AGENDA
BIG LAKE PLANNING COMMISSION MEETING
COUNCIL CHAMBERS

July 6, 2026
6:00 p.m.

<p>Prepared By: Kendra Lindahl, AICP Consulting Planner</p>	<p>Meeting Date: 7/6/2026</p>	<p>Item No. 7B</p>
<p>Item Description: *Public Hearing* - Comprehensive Plan Amendment, Zoning Text and Map Amendment, Development Stage Planned Unit Development, and a Preliminary Plat for "Preusse Lake Preserves" Subdivision on Outlot A of Big Lake Marketplace North Addition</p>	<p>Reviewed By: Hanna Klimmek, City Administrator</p>	
	<p>Reviewed By: Marie Popp, Community Development Director/EDA Executive Director</p>

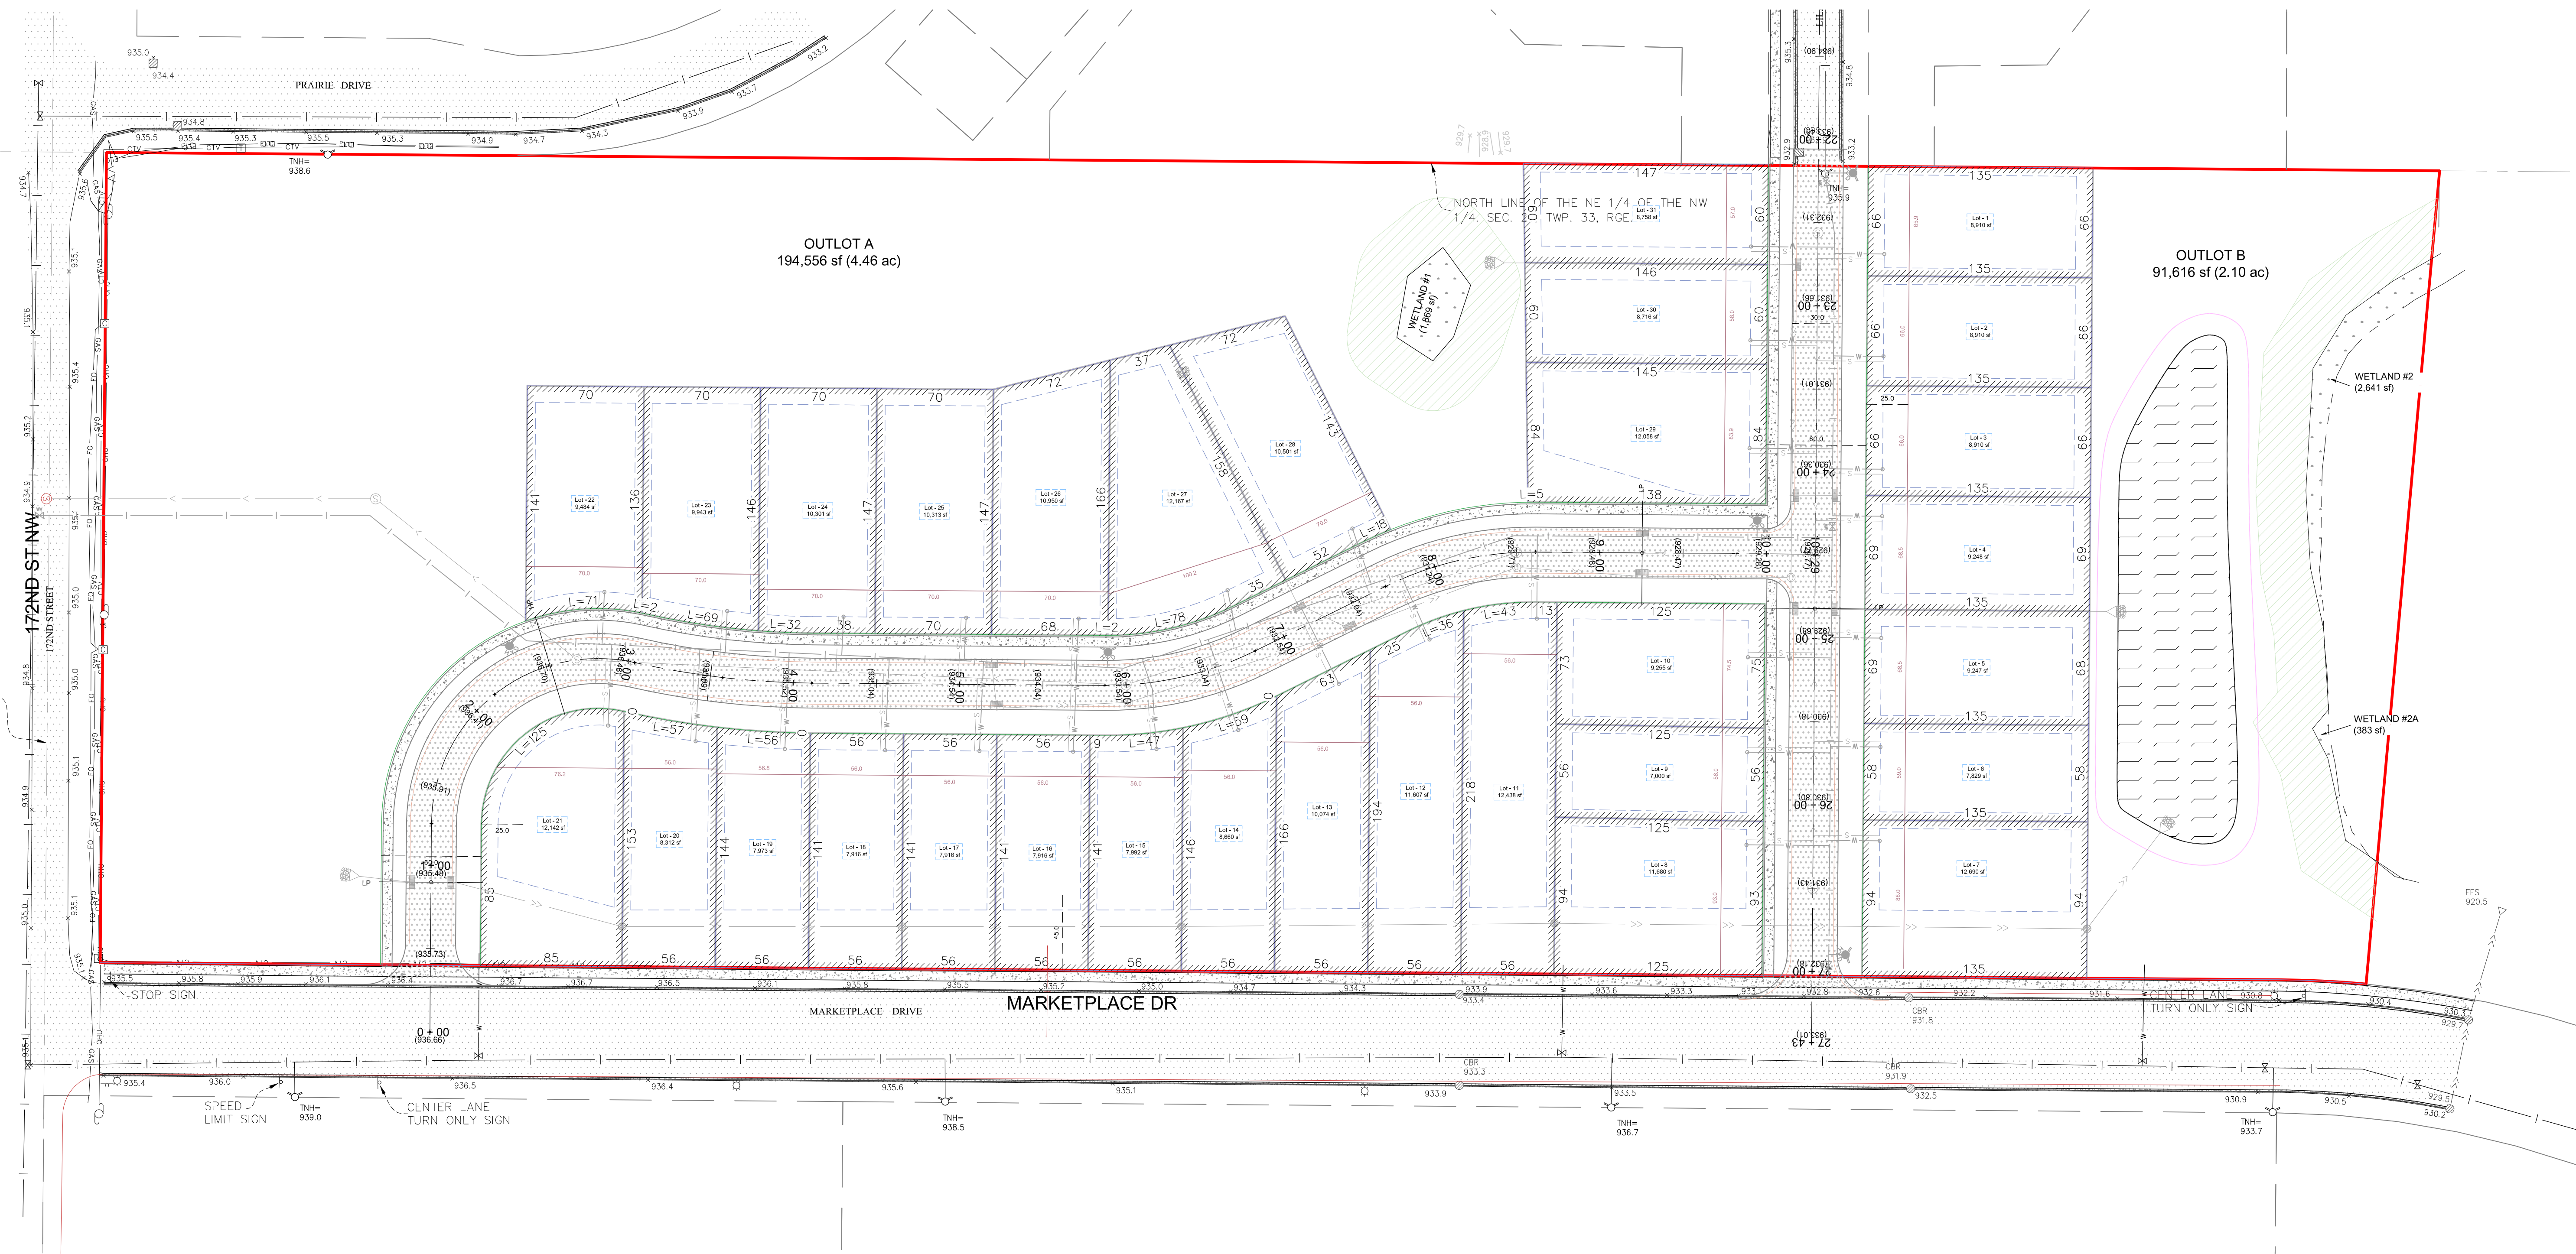
*the preliminary plat shows the required 45-foot setback, but the plans appear to show some conflicts that must be corrected.

5. The plans must show compliance with the 45-foot setback from Marketplace Drive and the required landscape buffer.
6. The Preliminary Plat for “Preusse Lake Preserves” on Outlot A of Big Lake Marketplace North Addition is approved in accordance with the plans and application received by the City on April 30, 2026, and additional material received on June 3, 2026, except as amended by this resolution.

LANDSCAPE PLAN

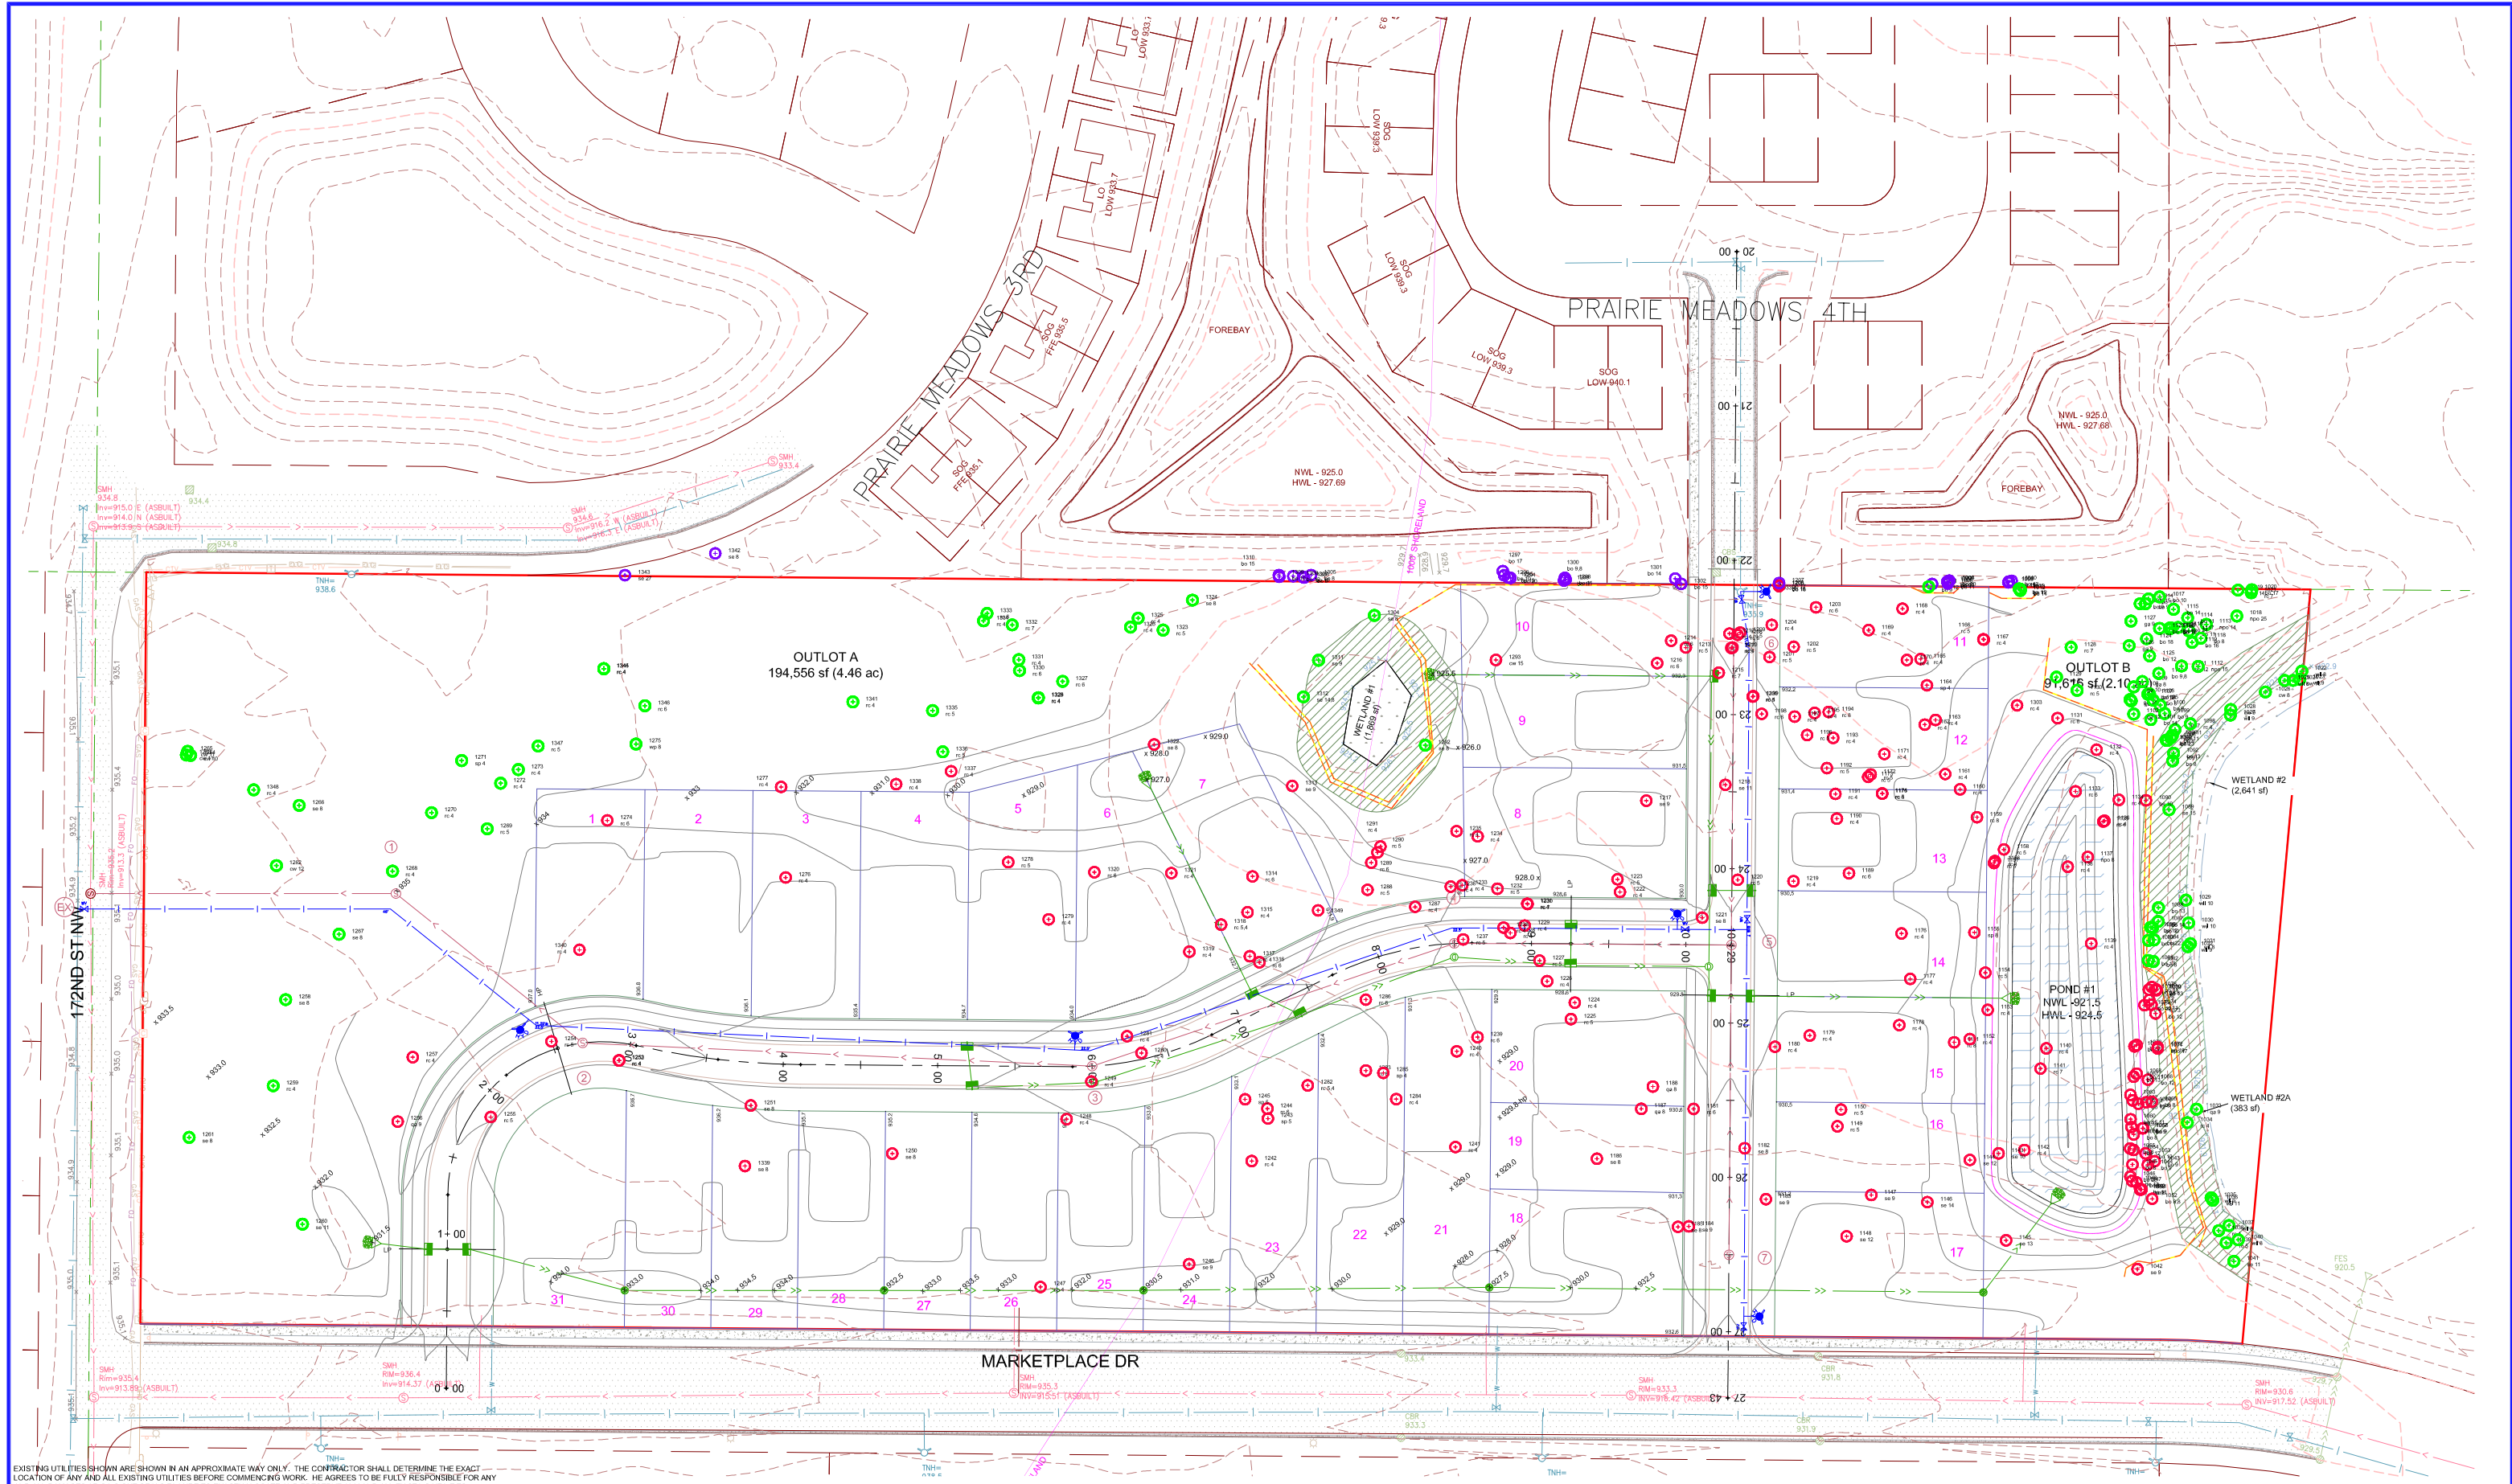
The landscape plan shows two trees per front yard of each home and additional buffering along the rear yards of homes that abut Marketplace Drive. In total they show 109 trees to be planted. However, the tree replacement plus the two trees in each front yard would require 116 trees. The plans should be revised to show a minimum of 116 trees on site.

Additionally, the trees and plantings along the rear yards of homes abutting Marketplace Drive are required to follow the Buffer Yard design standards found in Section 1006.06 Subd. 4.3(b). These requirements include spacing materials that the applicant has not demonstrated compliance with. The plans will need to be adjusted to show compliance with spacing requirements of the buffer yard. This is a range of 4 to 40 feet on center for deciduous trees and three to 15 feet on center for conifers. Compliance with these standards would likely result in the development meeting the tree replacement standards noted above.

Staff has requested the tree preservations tables in a more usable format to confirm that the replacements required are counted correctly, including counting the caliber inches of removed trees based on smallest trees removed first. It does not appear that the preparation of this plan and analysis will make a significant difference to the proposed preservation plan, however the condition has been added to provide these materials for a full analysis prior to approval of the final PUD plan. Overall, the plans generally comply and maintains a large number of trees, while replacing trees as required by Code.

14. The applicant must provide the Tree Preservation Plan table in an Excel format to demonstrate full compliance with Section 1107.11 on how to count caliber inches for replacement trees.

15. The applicant must revise the landscape plan to show compliance with buffer yard spacing and show the required number of trees (116). This includes adding at least 7 additional trees to the current plans.
